Review Comments #2

Project: Brighton Recovery Campus-Building A
Project No: 20160686

From: Jason Worthen
Date: March 20, 2017

BUILDING A RESPONSES

EP601

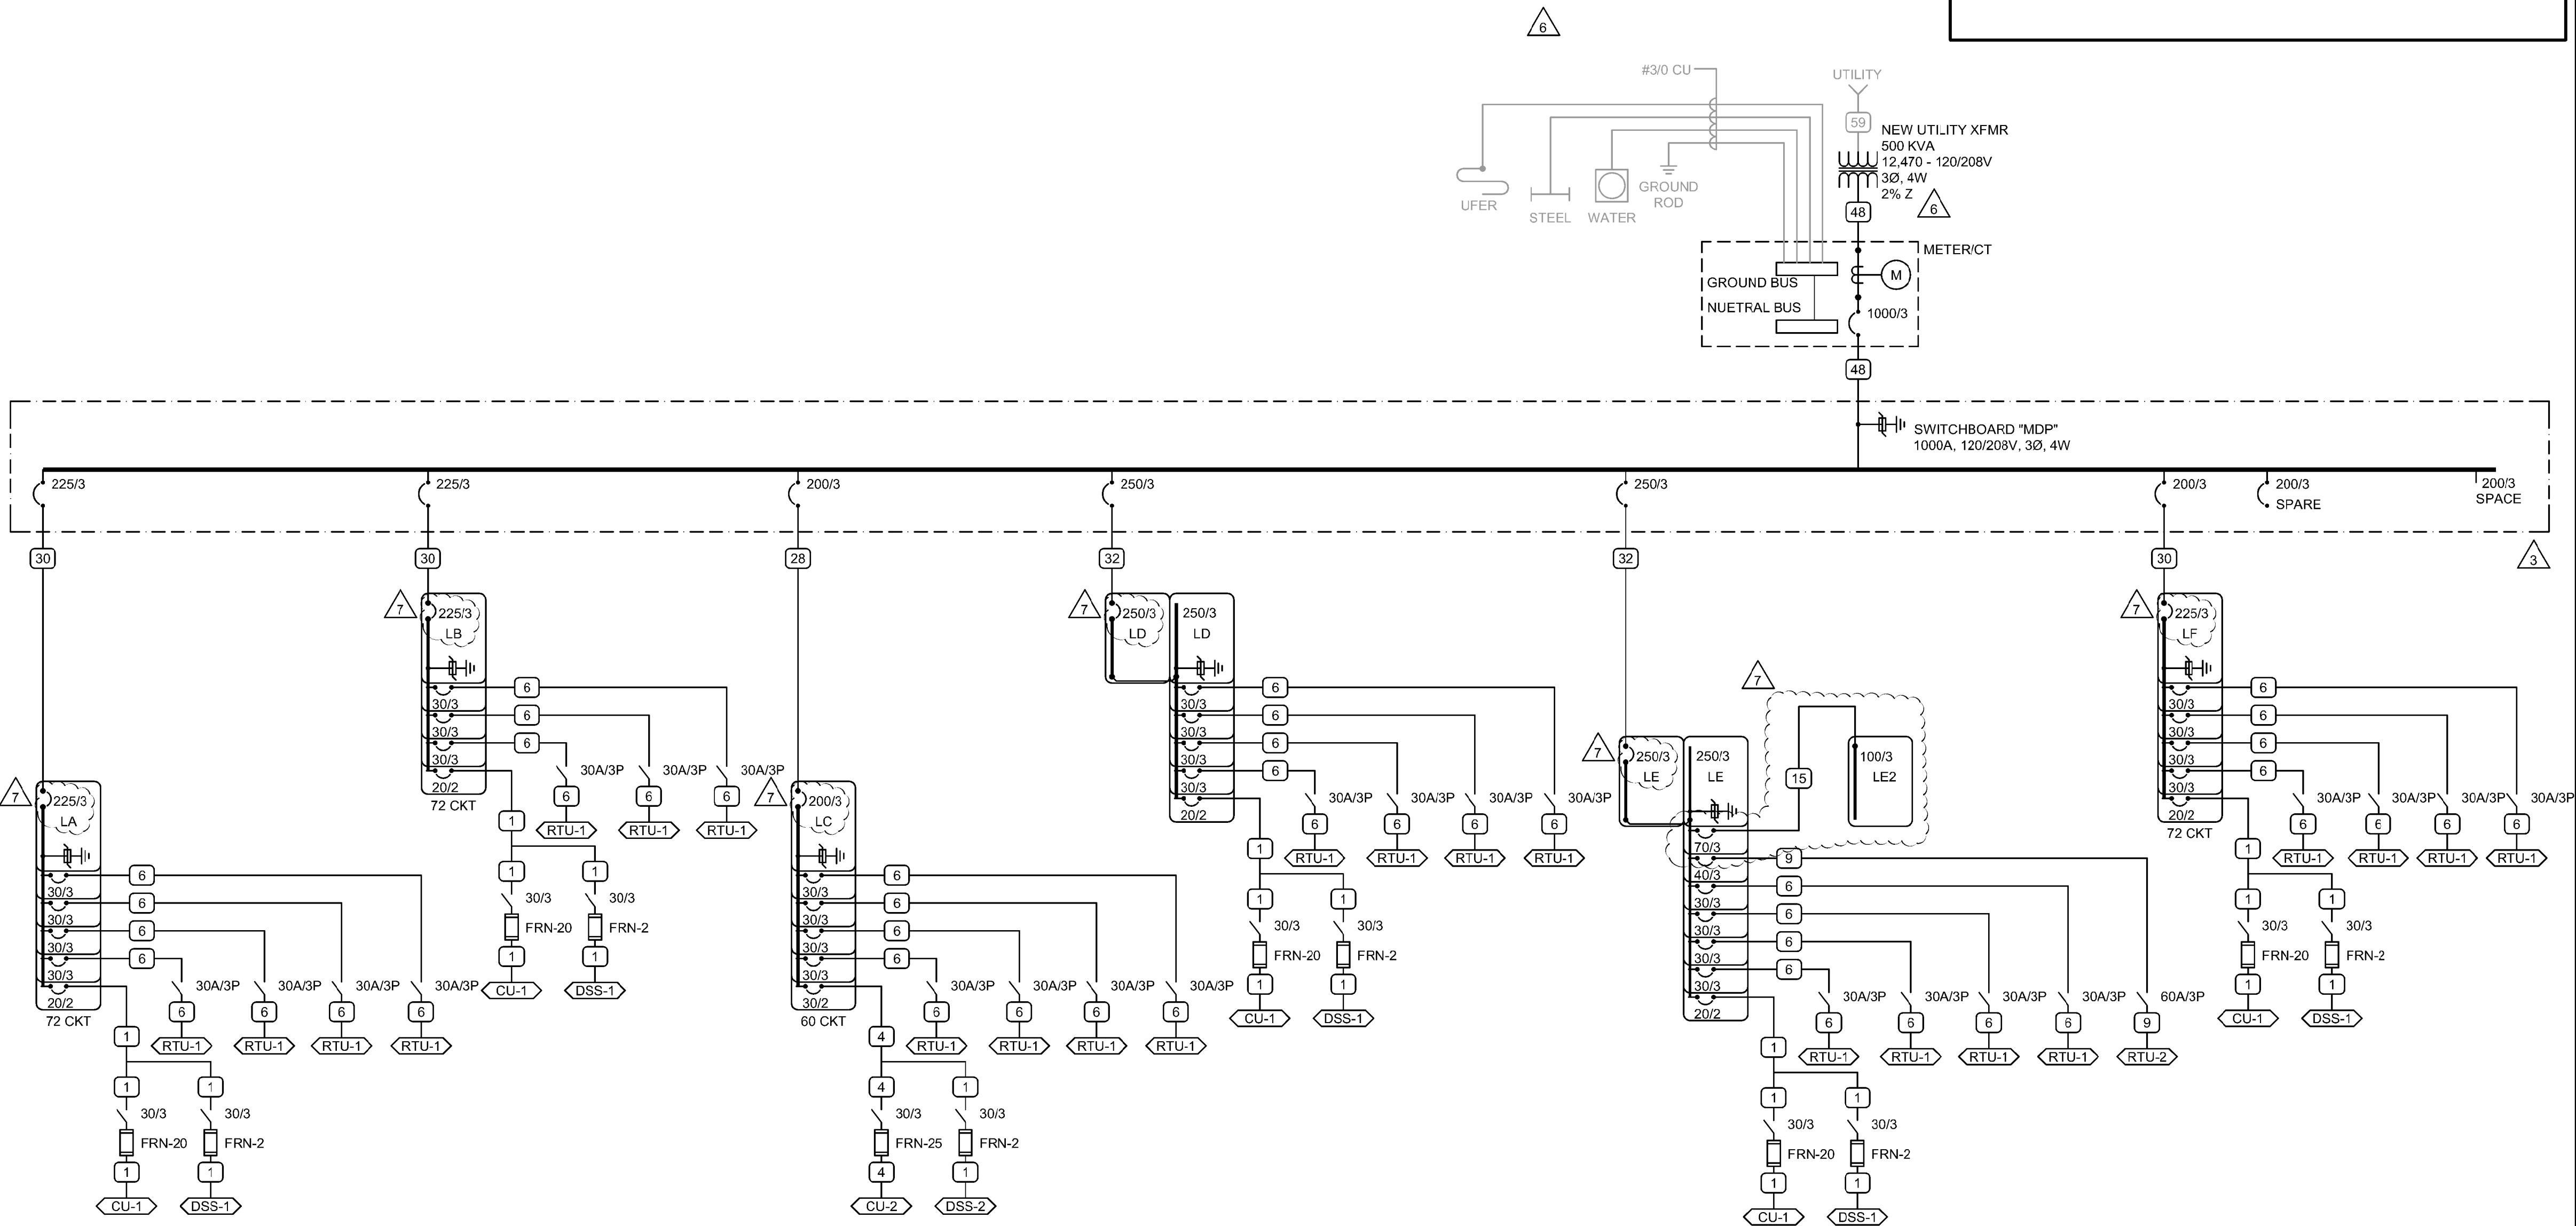
PC2: Sheet EP601: Per NEC 225.32 the main panel in each building is required to have a disconnecting means located at the point of entrance of the building. It appears that each of the building panels are provided with main lugs only. Please provide a disconnect for each panel. This comment also applies to sheets EP602 and EP603.

1. Changed all branch circuit panels from main lugs only to main circuit breaker panels.
2. Added panel LE2.

Response: All branch panels will be changed to have main circuit breakers.
